SUNDRY NOTICES AND REPORTS ON WELLS

8. Well Name and No.
TALCO 9 26 35 FEDERAL 3H ✓

PECOS DISTRICT
DRILLING OPERATIONS
CONDITIONS OF APPROVAL

OPERATOR'S NAME:	Endurance Resources, LLC
LEASE NO.:	NMNM117126
WELL NAME & NO.:	3H-Talco 9 26 35 Fed
SURFACE HOLE FOOTAGE:	2440'/N & 2280'/E
BOTTOM HOLE FOOTAGE	330'/N & 2280'/E
LOCATION:	Section 9, T.26 S., R.35 E., NMPM
COUNTY:	Lea County, New Mexico

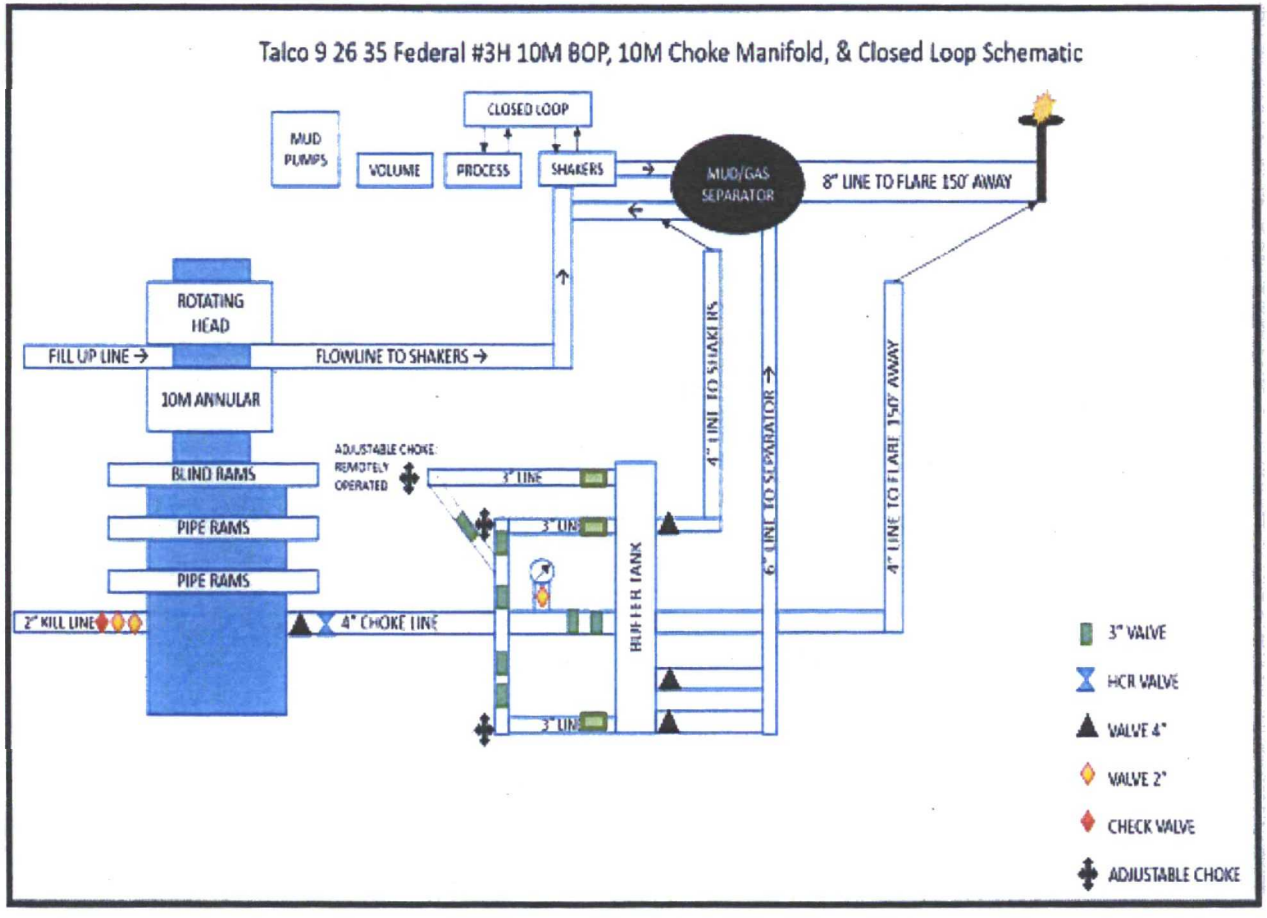
****The 10M Manifold must have 3 chokes. The diagram is missing valves between the chokes and the buffer tank. See attached modified diagram.**
